Docket No. 50-289

Thank you for providing us the requested information regarding OTSG Auxiliary Feedwater Nozzle Thermal Sleeve/Collar Weld Attachment.

October 17, 1980
TLL 509

Three Mile Island Nuclear Station, Unit 1 (TMI-1)
Operating License No. DPR-50
Docket No. 50-289
OTSG Auxiliary Feedwater Nozzle Thermal
Sleeve/Collar Weld Attachment

FIGURE 1

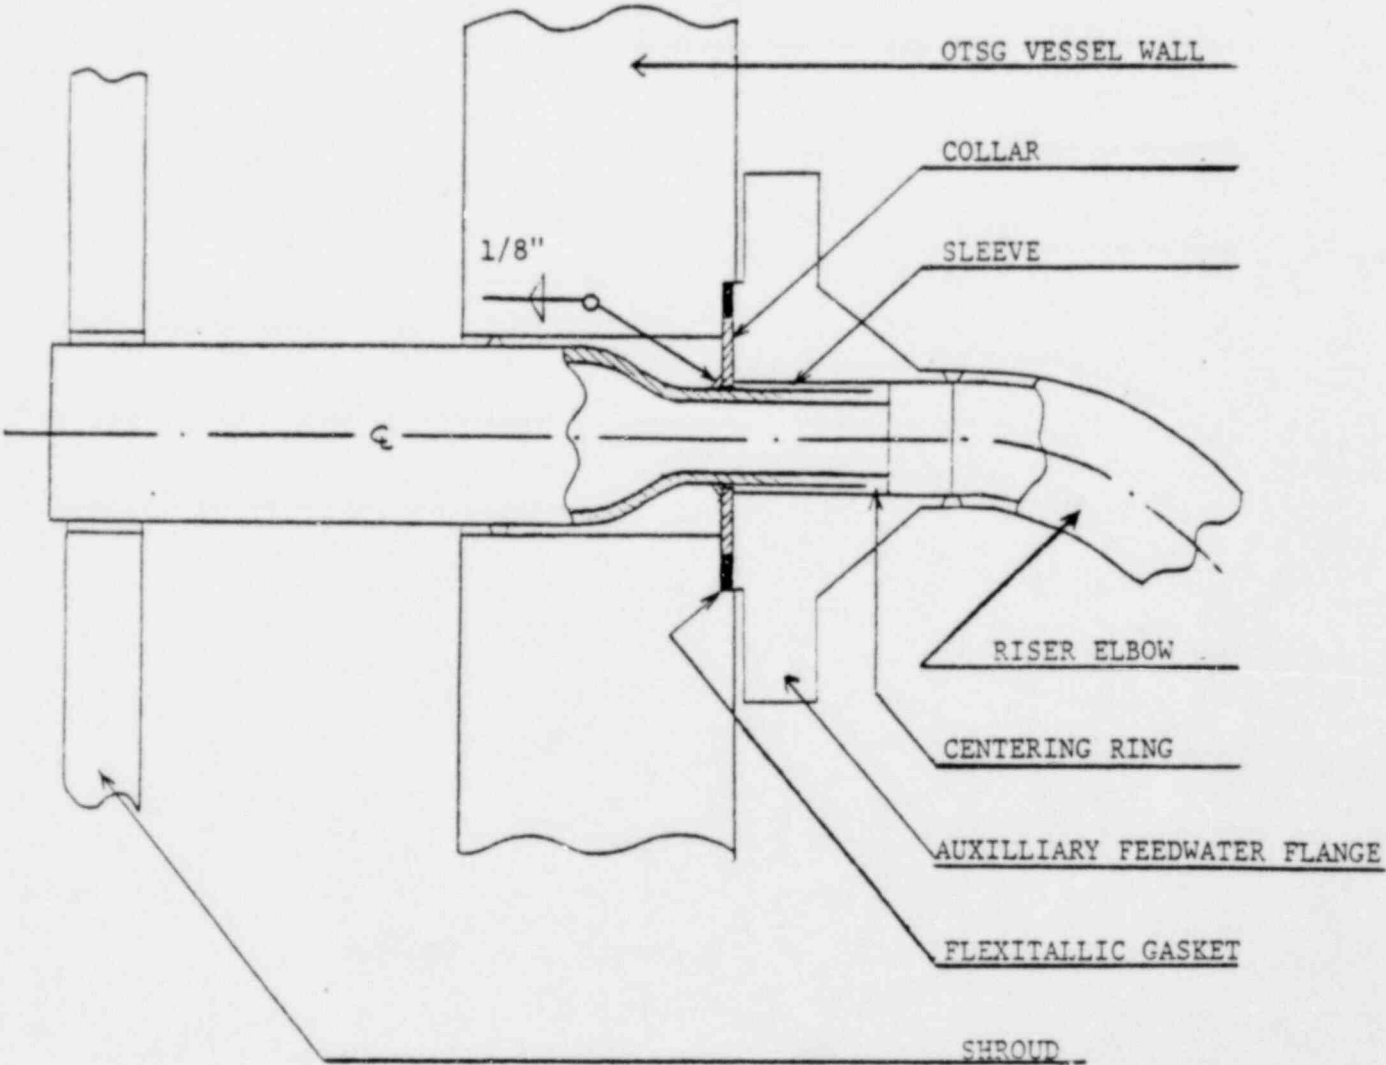
1. Design/environmental conditions leading to possible degradation of subject weld integrity. Identification of probable failure mode.

Injection of condensate or river water into a nozzle thermal sleeve (Figure 1) at steady state temperature will cause thermal shock. Translating flow conditions into stress, transient thermal conditions create peak principal stresses high enough to produce crack initiation in as little as 10 cycles for a temperature difference, between the sleeve and the collar, equal to 500°F. About 100 cycles can be anticipated for a temperature difference equal to 250°F. Each of these estimates is based on the ASME, BPVC, Section III, Design Fatigue Curves. These temperature differences are realizable as a result of short bursts of cold emergency feedwater or more sustained flow using somewhat warmer emergency feedwater.

One emergency feedwater usage represents one thermal fatigue cycle regardless of how many times feedwater was called for during the emergency event or what the feedwater temperature was. The basis for this assumption is that once the thermal sleeve was thermally shocked, the peak stress field is constant.

We will partially drain the OTSG and inspect Z-axis nozzles. If cracking is noted on these nozzles, the remainder will also be inspected and weld repaired as required. Z-axis nozzles were inspected in 1977 and found free of cracks. Only two thermal cycles have been recorded since these inspections.
